Addendum #5

Construct Bridges at T2 R9 Training Site

Project No. 23TR17-602-D2, Bid Number #19-006

15 July 2019

ATTACHMENT ONE - ABI ROAD SECTIONS

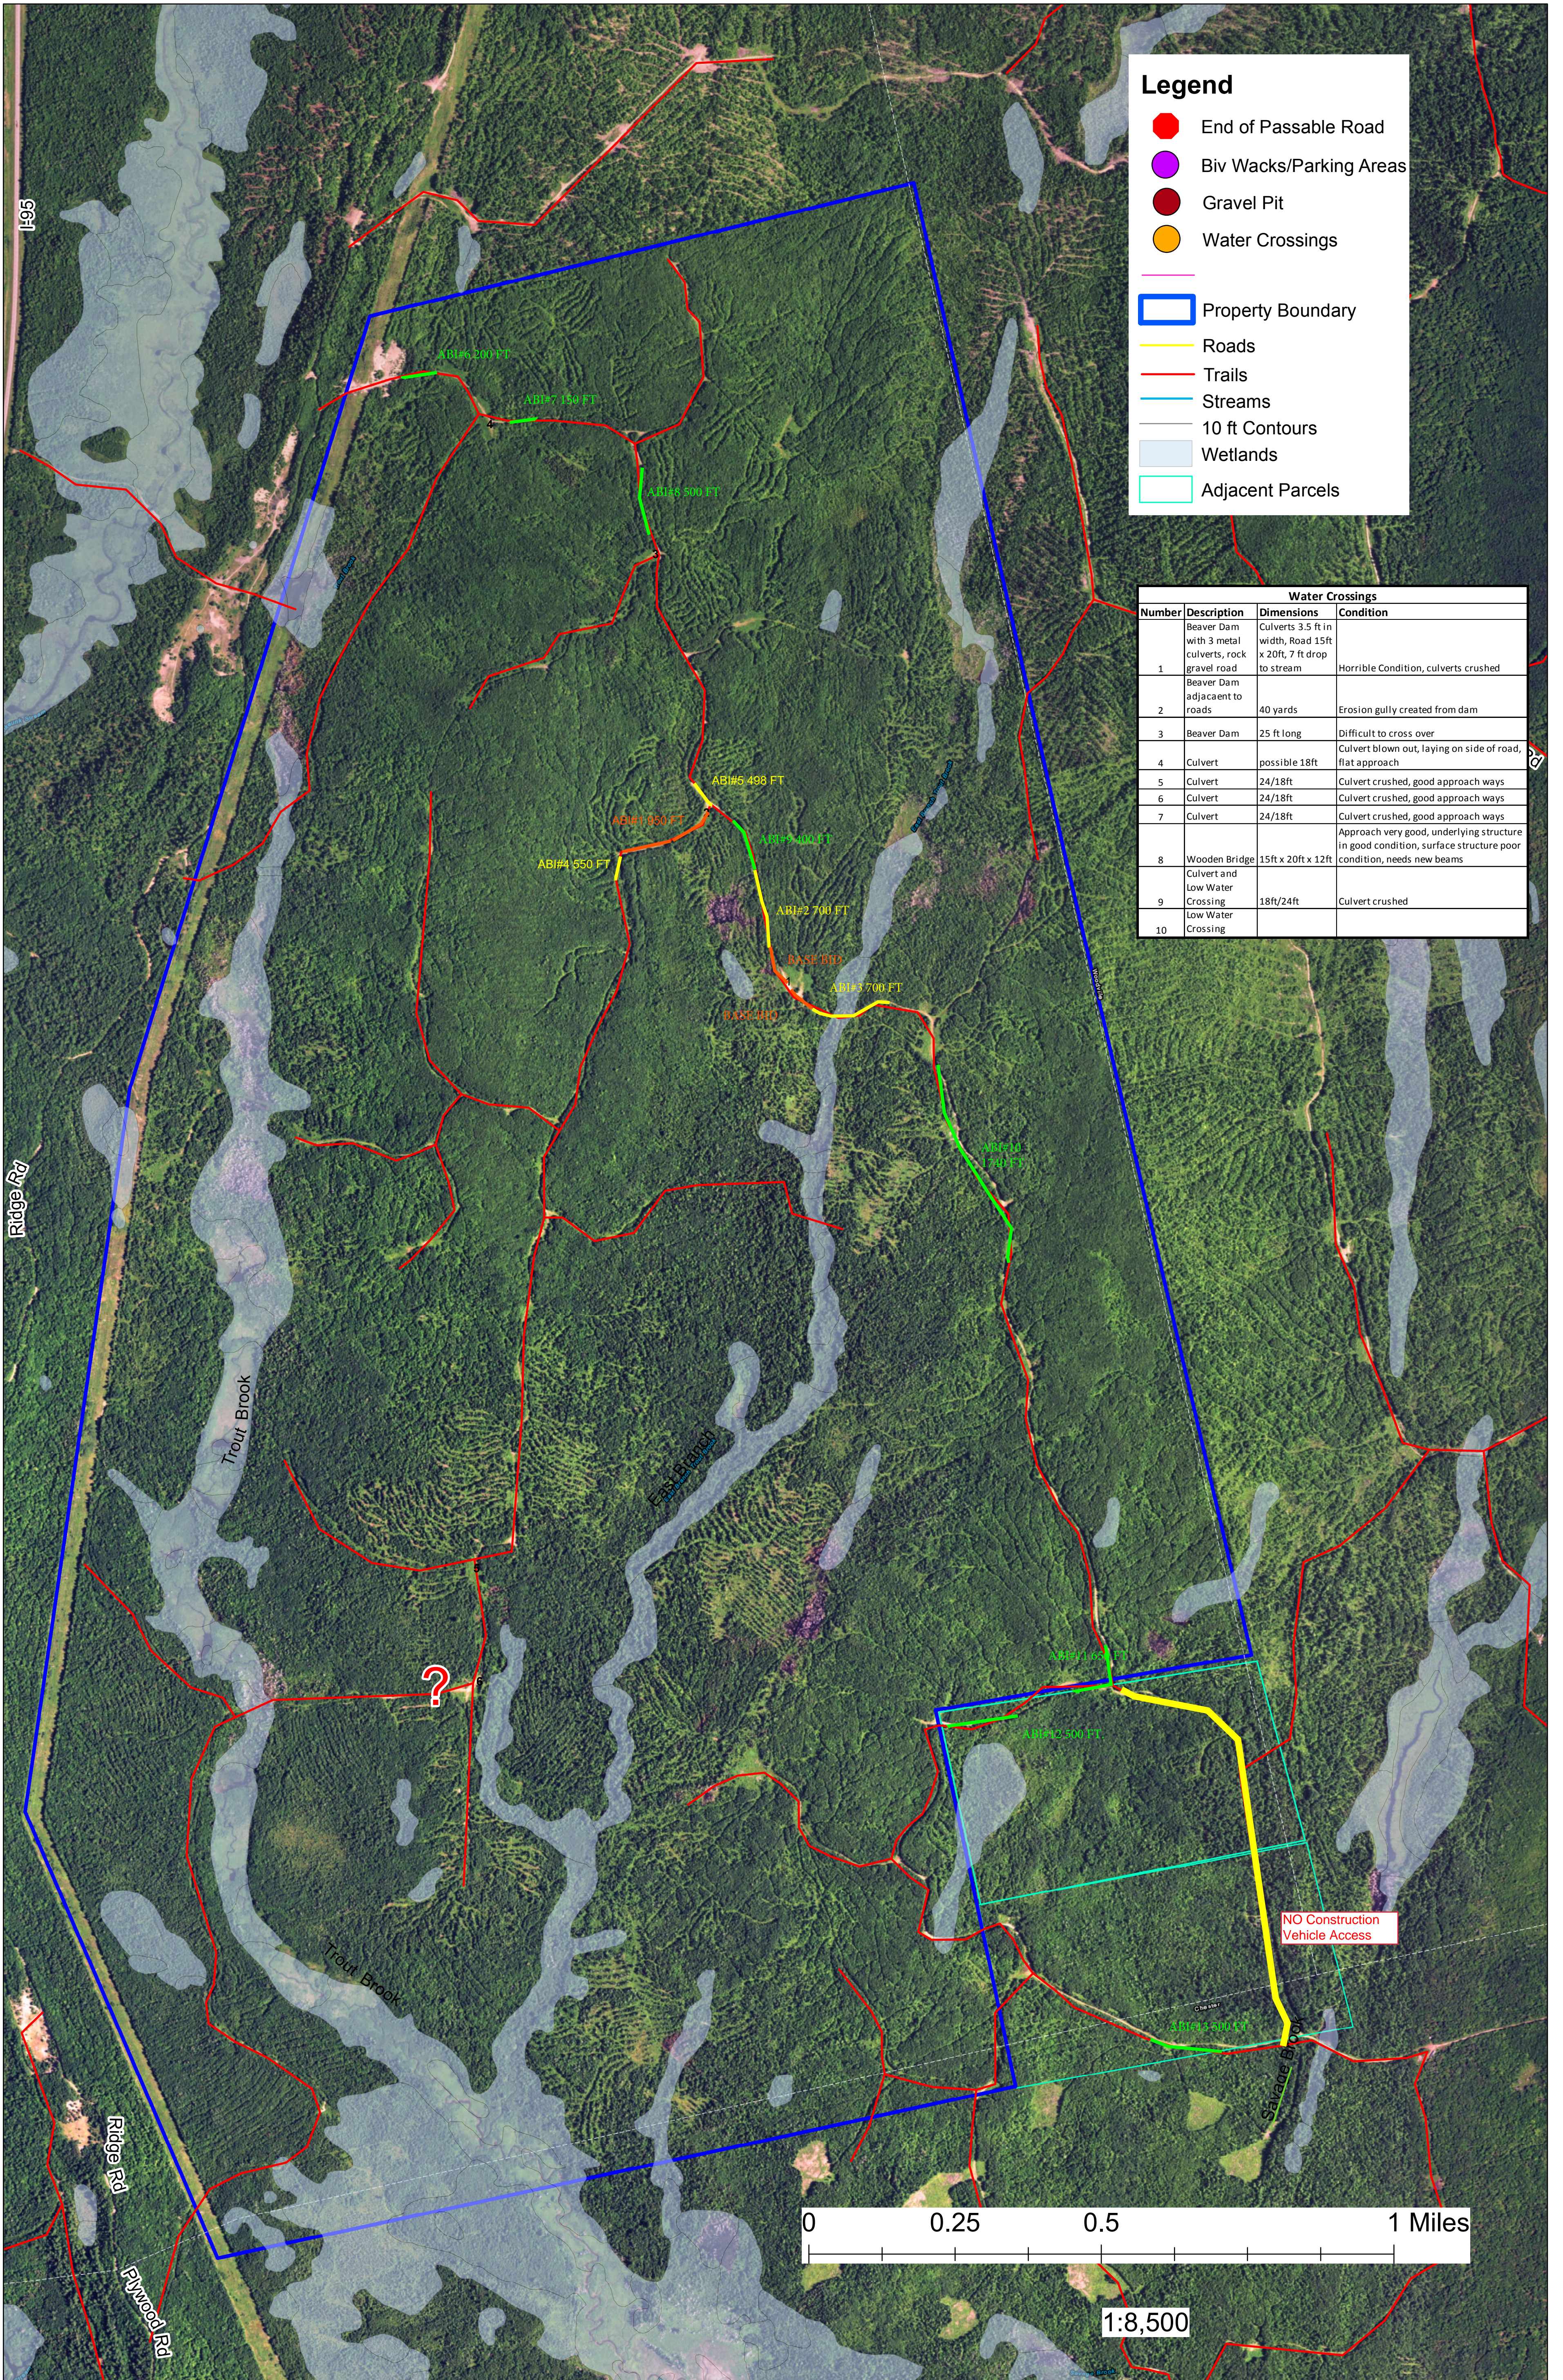
1. Road fabric is required on the entire section of rebuilt road.
2. Contractor will work with the Owner to establish "Borrow Pits" that would be closed out by the Owner as required.

- (1) ABI#1: 950 Linear feet. of gravel Road, 475 linear ft each side from center point of crossing B-02-01. IAW Attachment 1 and Roadway Cross Section on Sheet C-501.

- (2) ABI#2: 700 Linear feet of Gravel Road at Crossing A-13-01 IAW Plans and Specifications (0+00 to 7+00).
- (3) ABI#3: 700 Linear feet of Gravel Road at Crossing A-13-01 IAW Plans and Specifications (13+00 to 20+00).

- (4) ABI#4: 550 feet of gravel Road at B-02-01 IAW Plans and Specifications (0+00 to 5 +50).
- (5) ABI#5: 498 feet of gravel Road at B-02-01 IAW Plans and Specifications (14+50 to 19+48).

- (6) ABI#6 200 Linear feet of gravel Road as shown in Attachment 1 and Roadway Cross Section on Sheet C-501.
- (7) ABI#7 150 Linear feet of gravel Road as shown in Attachment 1 and Roadway Cross Section on Sheet C-501.

- (8) ABI#8 500 Linear feet of gravel Road as shown in Attachment 1 and Roadway Cross Section on Sheet C-501.
- (9) ABI#9 400 Linear feet of gravel Road as shown in Attachment 1 and Roadway Cross Section on Sheet C-501.

- (10) ABI#10 1740 Linear feet of gravel Road as shown in Attachment 1 and Roadway Cross Section on Sheet C-501.
- (11) ABI#11 650 Linear feet of gravel Road as shown in Attachment 1 and Roadway Cross Section on Sheet C-501.

- (12) ABI#12 500 Linear feet of gravel Road as shown in Attachment 1 and Roadway Cross Section on Sheet C-501.
- (13) ABI#13 500 Linear feet of gravel Road as shown in Attachment 1 and Roadway Cross Section on Sheet C-501.
